IEEE802.1CB – REQUEST FOR RATIONALE  
IN AUTOMOTIVE APPLICATIONS TO BE  
INCLUDED IN IEEE802.1DG.

2021-04-06

IEEE contribution

# Addressing

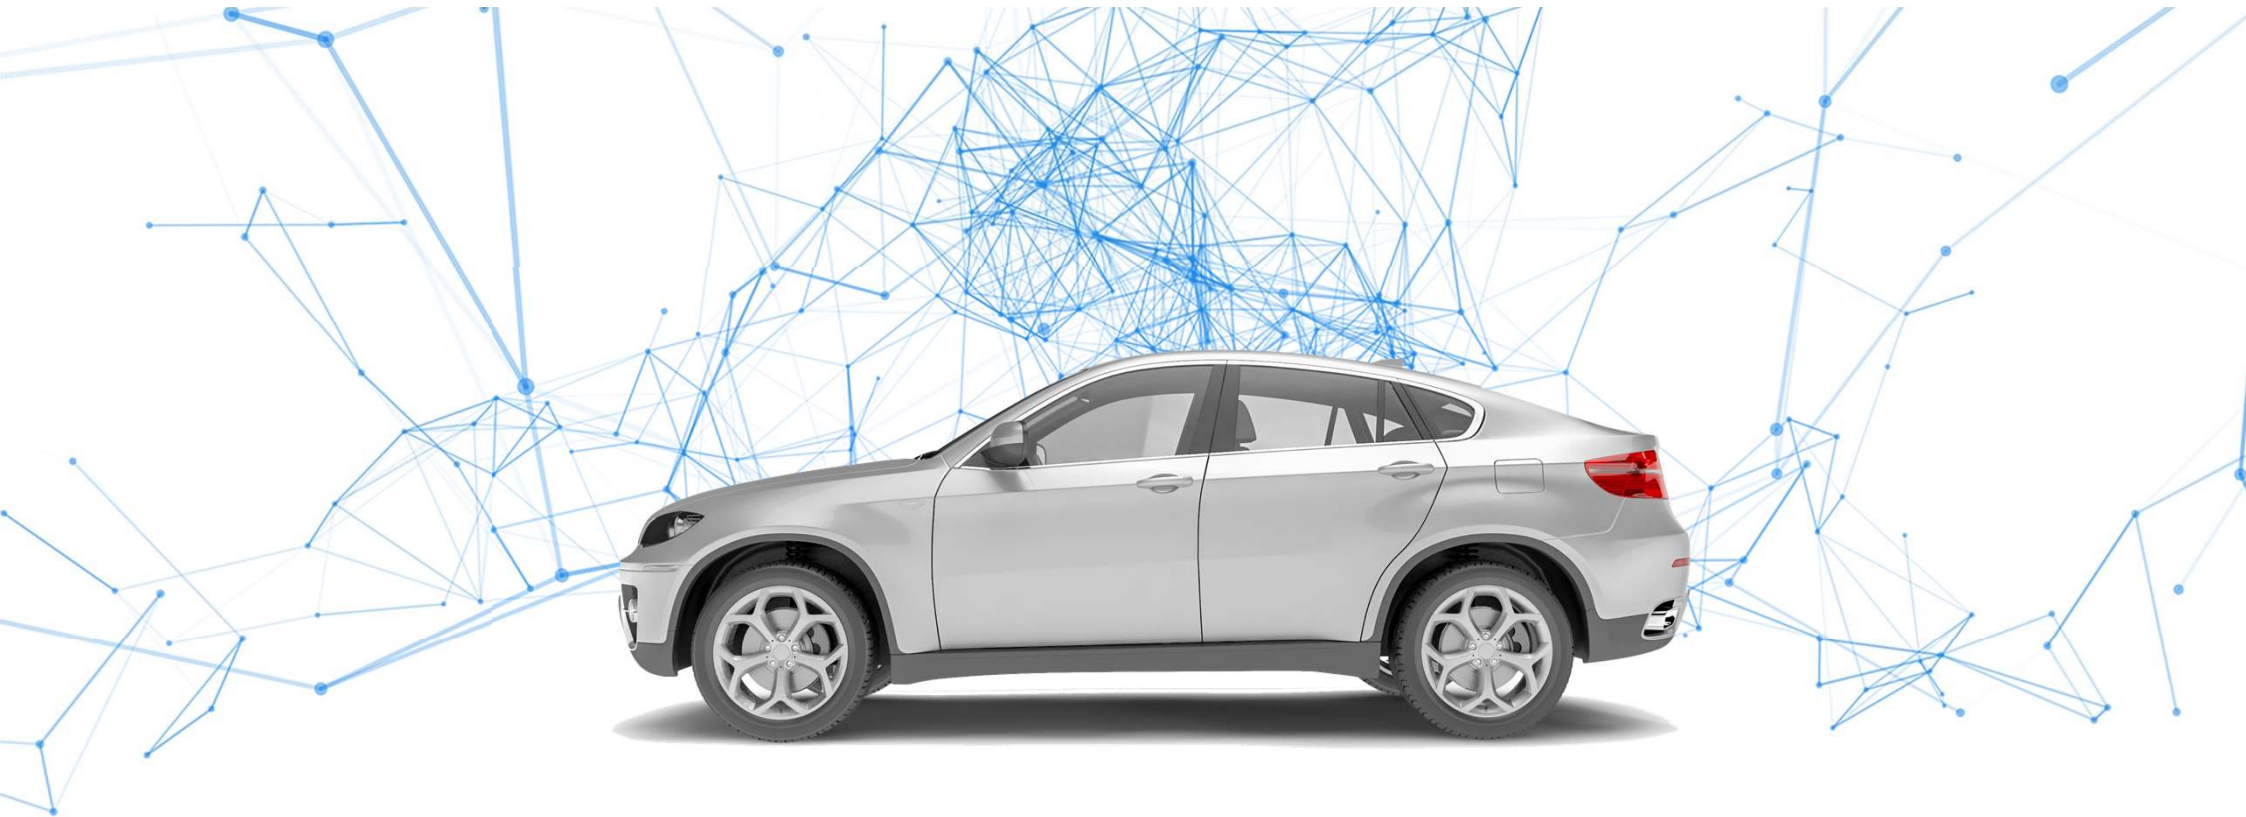
- Require use of at least one VLAN Tag on all FRER frames.
- Require per VLAN ARL table learning for source addresses.
- Require Multicast (MAC) destination addressing for all FRER frames.
